Regulation No. 113 (Headlamps emitting a symmetrical passing beam)

Proposal for the 01 series of amendments

Submitted by the expert from the Working Party "Brussels 1952"*

The text reproduced below was prepared by the expert from the Working Party "Brussels 1952" (GTB) to change the basis for the photometric requirements from 12.0 V to 13.2 V and to update the requirements in line with technical progress. The modifications to the existing text of the Regulation are marked in bold for new or strikethrough for deleted characters.

Figure 13

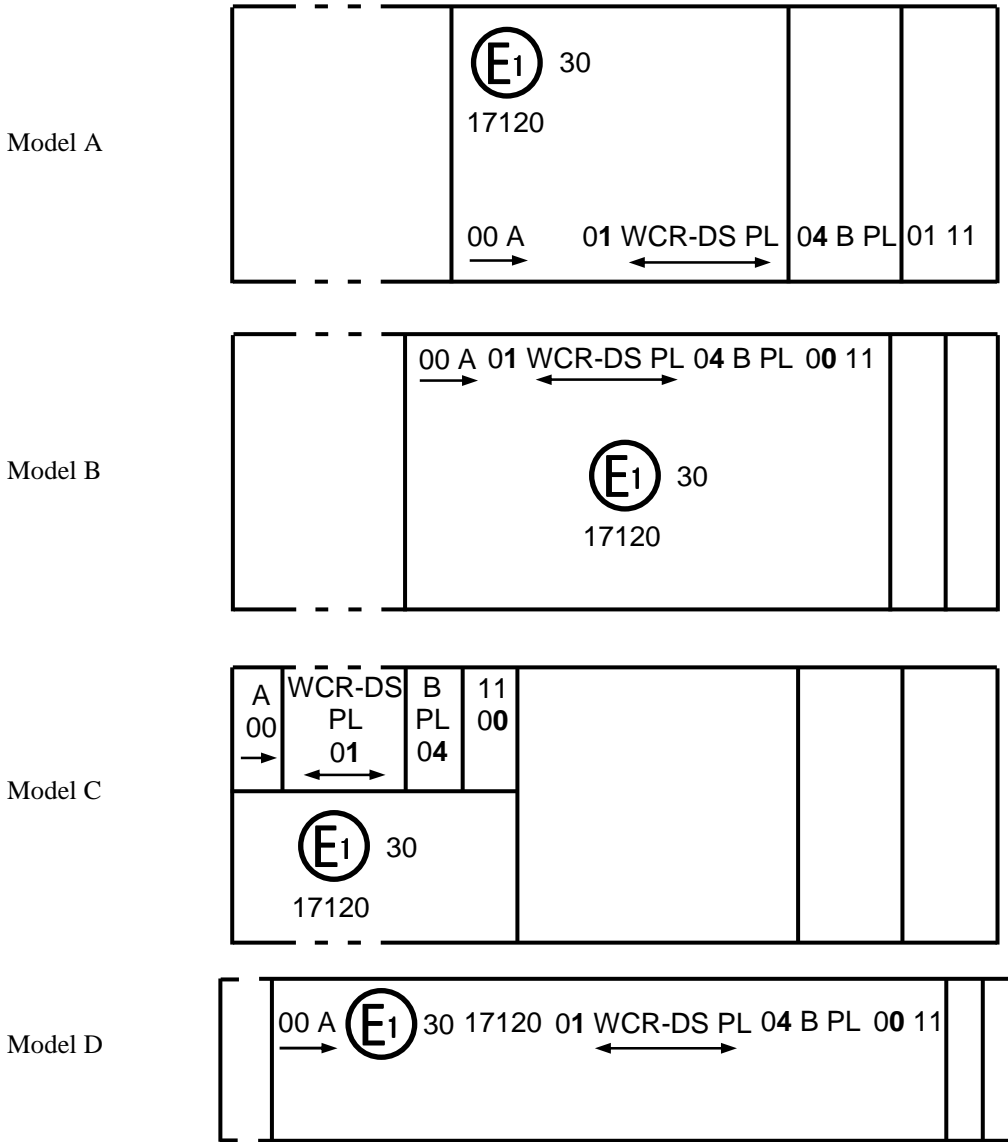
A headlamp, Class D, with a passing beam and a driving beam with a maximum intensity comprised between ~~86,250 and 101,250~~ **123,625 and 145,125 candelas** (as indicated by the number 30), approved in accordance with the requirements of this Regulation ~~in its original form (00)~~ **as amended by the 01 series of amendments** and incorporating a lens of plastic material,

A **class B** front fog lamp approved in accordance with the **03** series of amendments to Regulation No. 19 and incorporating a lens of plastic material,

A front direction indicator lamp of Category 11 approved in accordance with the **00 04** series of amendments to Regulation No. 50.

Figure 14

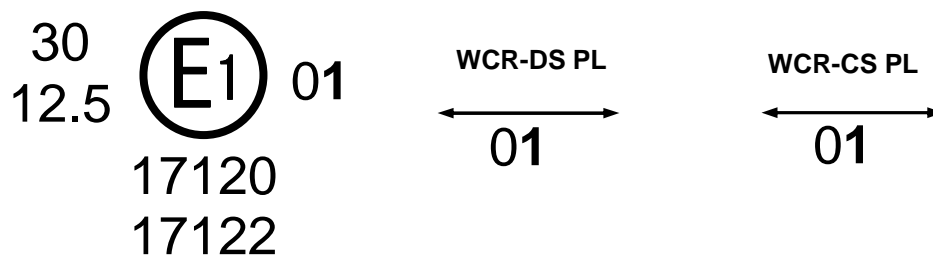
Either a headlamp, Class D, with a passing and a driving beam with a maximum luminous intensity comprised between ~~86,250 and 101,250 candelas~~ **86,250 123,625 and 145,125** (as indicated by the number 30), approved in Germany (E1) in accordance with the requirements of this Regulation ~~in its original form (00)~~ **as amended by the 01 series of amendments**, which is reciprocally incorporated with a front position lamp approved in accordance with Regulation No. 50 in its original form (00);

A headlamp, Class C, with a passing beam and a driving beam with a maximum luminous intensity comprised between ~~33,750 cd and 45,000 cd~~ **48,375 and 64,500 candelas** (as indicated by the number 12.5), approved in Germany (E1) in accordance with the requirements of this Regulation ~~in its original form (00)~~ **as amended by the 01 series of amendments**, which is reciprocally incorporated with the same front position lamp as above;

Figure A
Spherical Coordinate Measuring System

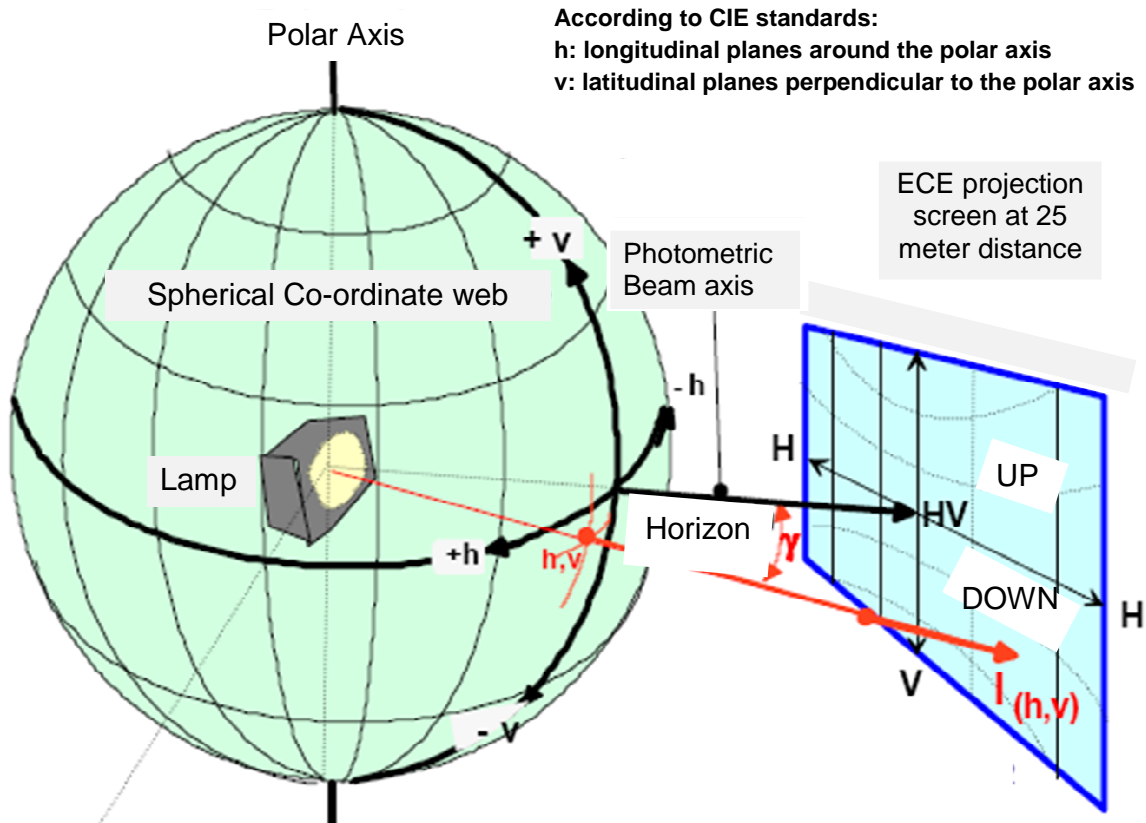
Annex 3, amend to read:

"Spherical Coordinate Measuring System and Test Point Locations

$$E_{25m} = I_{(h,v)} \times \cos \gamma / r^2$$

The angular co-ordinates are specified in degrees on a sphere with a vertical polar axis according to CIE publication No. 70-1987 "The measurement of absolute luminous intensity distributions", i.e. corresponding to a goniometer with a horizontal ("elevation") axis fixed to the ground and a second, moveable ("rotation") axis perpendicular to the fixed horizontal axis.

Figure B
 Passing beam - test points and Zones for Class A headlamp(s):

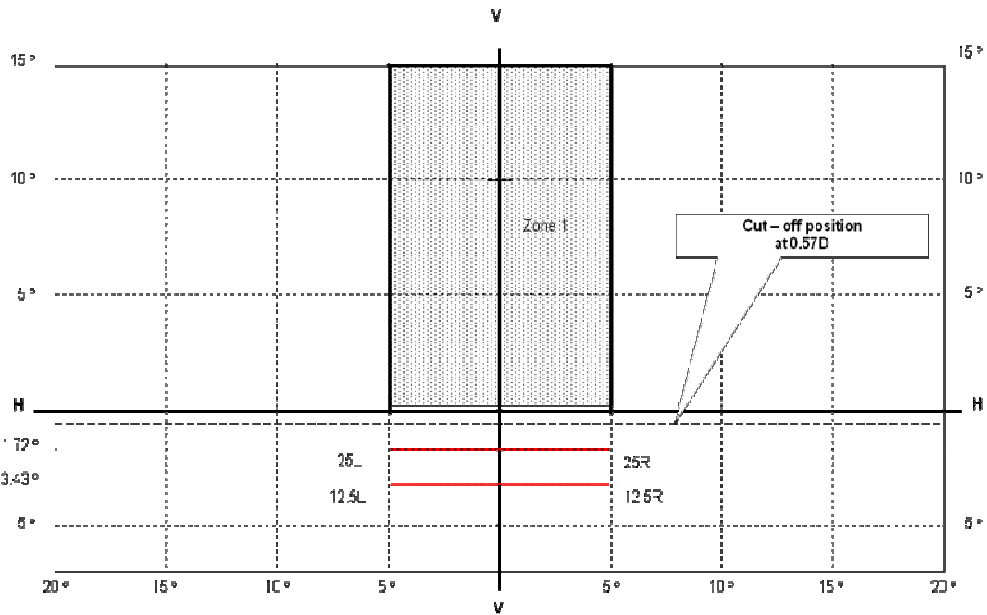
6.2.5.1. For Class A headlamps (Figure B in Annex 3):

<i>Test point/ line/zone</i>	<i>Angular coordinates - degrees*</i>		<i>Required luminous intensity in cd</i>
Any point in Zone 1	0° to 15°U	5°L to 5°R	≤ 320 cd
Any point on line 25L to 25R	1.72°D	5°L to 5°R	≥ 1,100 cd
Any point on line 12.5L to 12.5R	3.43°D	5°L to 5°R	≥ 550 cd

Figure C
 Passing beam test points and Zones for Class B headlamp(s):

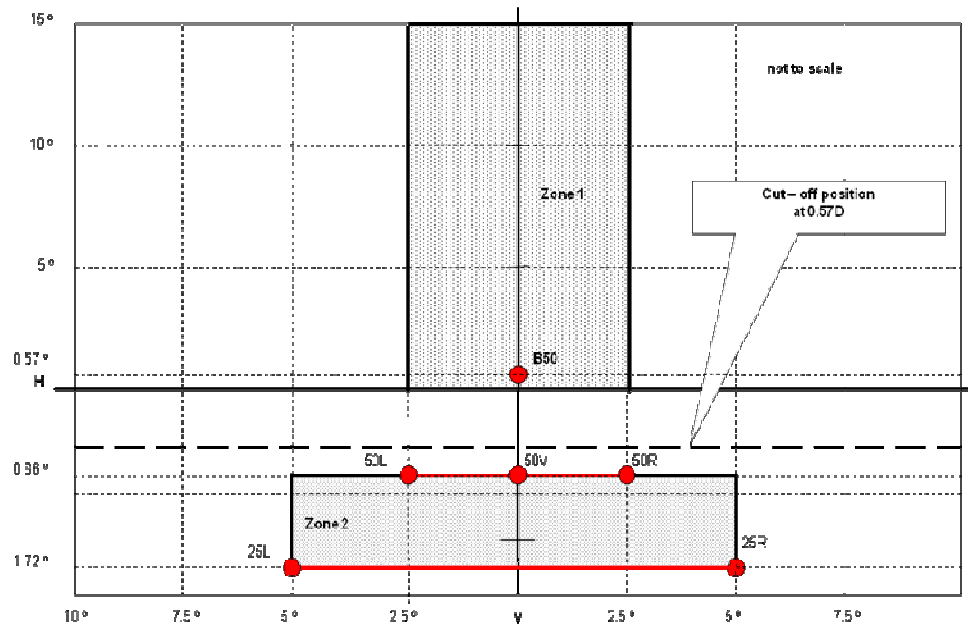
6.2.5.2. For Class B headlamps (Figure C in Annex 3):

<i>Test/point/ line/zone</i>	<i>Angular coordinates - degree*</i>		<i>Required luminous intensity in cd</i>
Any point in Zone 1	0° to 15°U	5°L to 5°R	≤ 700 cd
Any point on line 50L to 50R except 50V	0.86°D	2.5°L to 2.5°R	≥ 1,100 cd
Point 50V	0.86°D	0	≥ 2,200 cd
Any point on line 25L to 25R	1.72°D	5°L to 5°R	≥ 2,200 cd
Any point in Zone 2	0.86°D to 1.72°D	5°L to 5°R	≥ 1,100 cd

Figure D
 Passing beam - position of test points and zones for Class C, D and E headlamp(s):

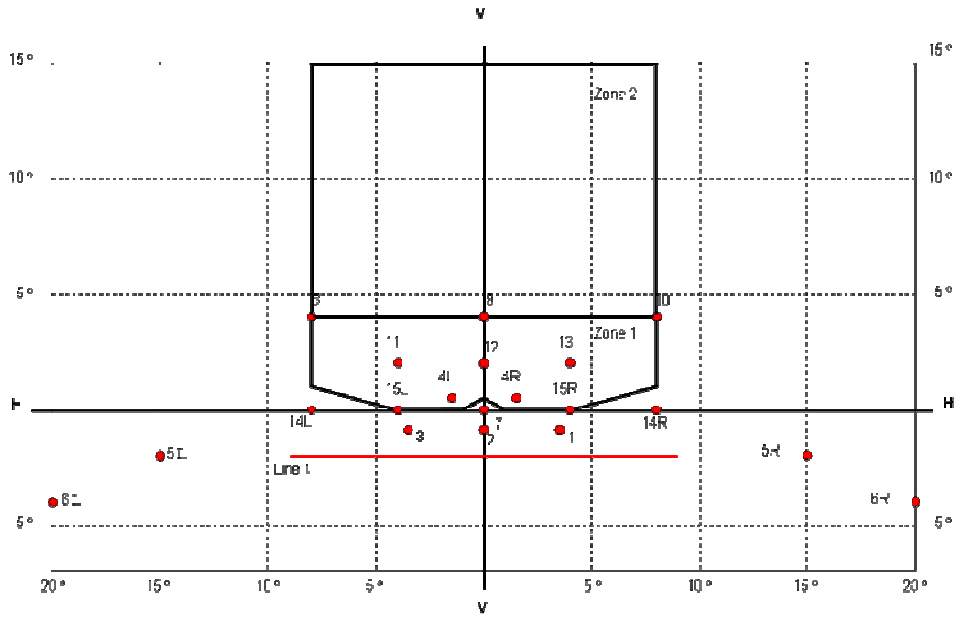
6.2.5.3. For Class C, D or E headlamp (Figure D in Annex 3):

Test point/ line/ zone	Test point angular coordinates - degrees*		Required luminous intensity in cd			
			Minimum			Maximum
			Class C	Class D	Class E	Class C,D,E
1	0.86°D	3.5°R	2,000	2,000	2,500	13,750
2	0.86°D	0	2,450	4,900	4,900	-
3	0.86°D	3.5°L	2,000	2,000	2,500	13,750
4	0.50°U	1.50°L and 1.50°R	--	--	--	900
5	2.00°D	15°L and 15°R	550	1,100	1,100	--
6	4.00°D	20°L and 20°R	150	300	600	-
7	0	0	--	--	--	1,700
Line 1	2.00°D	9°L to 9°R	1,350	1,350	1,900	-
8**	4.00°U	8.0°L	$\sum 8 + 9 + 10 \geq 150 \text{ cd}^{**}$			700
9**	4.00°U	0				700
10**	4.00°U	8.0°R				700
11**	2.00°U	4.0°L	$\sum 11 + 12 + 13 \geq 300 \text{ cd}^{**}$			900
12**	2.00°U	0				900
13**	2.00°U	4.0°R				900
14**	0	8.0°L and 8.0°R	50 cd**	50 cd**	50 cd**	-
15**	0	4.0°L and 4.0°R	100 cd**	100 cd**	100 cd**	900
Zone 1	1°U/8°L-4°U/8°L-4°U/8°R- 1°U/8°R-0/4°R-0/1°R-0.6°U/0- 0/1°L-0/4°L-1°U/8°L		--	--	--	900
Zone 2	>4U to <15 U	8°L to 8°R	--	--	--	700

Figure E
 Primary Driving Beam - position of test points

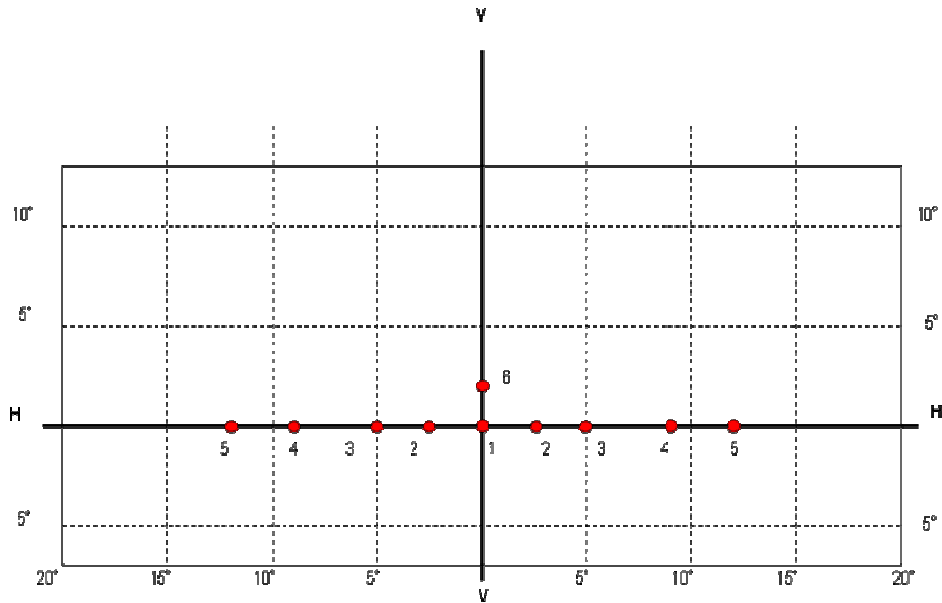
- 6.3.3.1. The luminous intensity of a Primary Driving Beam shall conform to the following table (Figure E in Annex 3):**

Test point number	Test point angular coordinates - degrees*	Required luminous intensity [cd]					
		Class B		Class C		Class D, E	
		MIN	MAX	MIN	MAX	MIN	MAX
1	H-V	16,000	---	20,000	---	30,000	---
2	H-2.5°R and 2.5°L	9,000	---	10,000	---	20,000	---
3	H-5°R and 5°L	2,500	---	3,500	---	5,000	---
4	H-9°R and 9°L	---	---	2000	---	3,400	---
5	H-12°R and 12°L	---	---	600	---	1,000	---
6	2°U-V	---	---	1000	---	1,700	---
	MIN luminous intensity of the maximum (I_M)	20,000	---	25,000	---	40,000	---
	MAX luminous intensity of the maximum (I_M)	---	215,000	---	215,000	---	215,000

Figure F
Secondary Driving Beam - position of test points

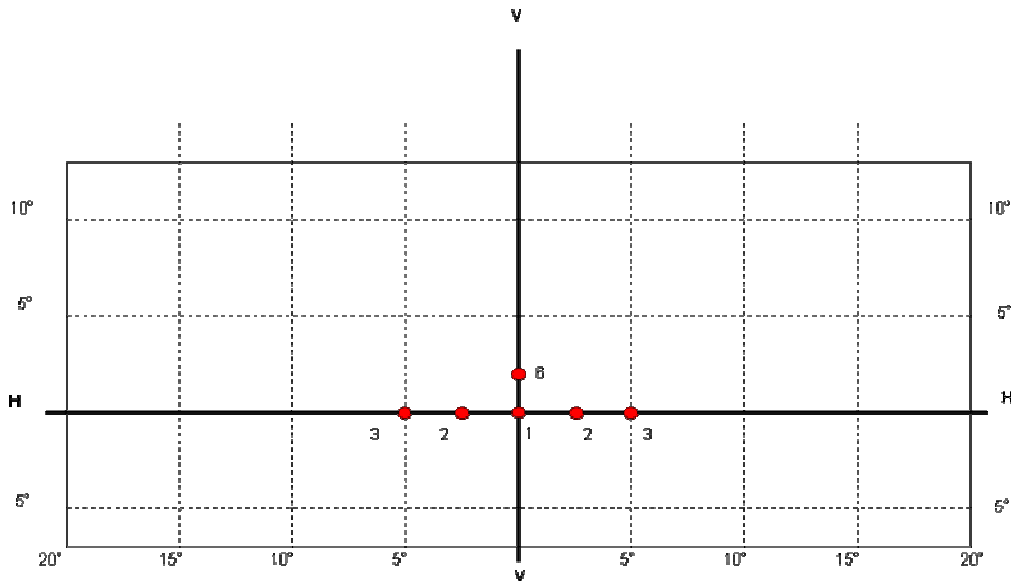
6.3.3.2. The luminous intensity of a Secondary Driving Beam shall conform to the following table (Figure F in Annex 3):

Test point number	Test point angular coordinates - degrees*	Required luminous intensity [cd]					
		Class B		Class C		Class D, E	
		MIN	MAX	MIN	MAX	MIN	MAX
1	H-V	16,000	---	20,000	---	30,000	---
2	H-2.5°R and 2.5°L	9,000	---	10,000	---	20,000	---
3	H-5°R and 5°L	2,500	---	3,500	---	5,000	---
6	2°U-V	---	---	1,000	---	1,700	---
	MIN luminous intensity of the maximum (I_M)	20,000	---	25,000	---	40,000	---
	MAX luminous intensity of the maximum (I_M)	---	215,000	---	215,000	---	215,000
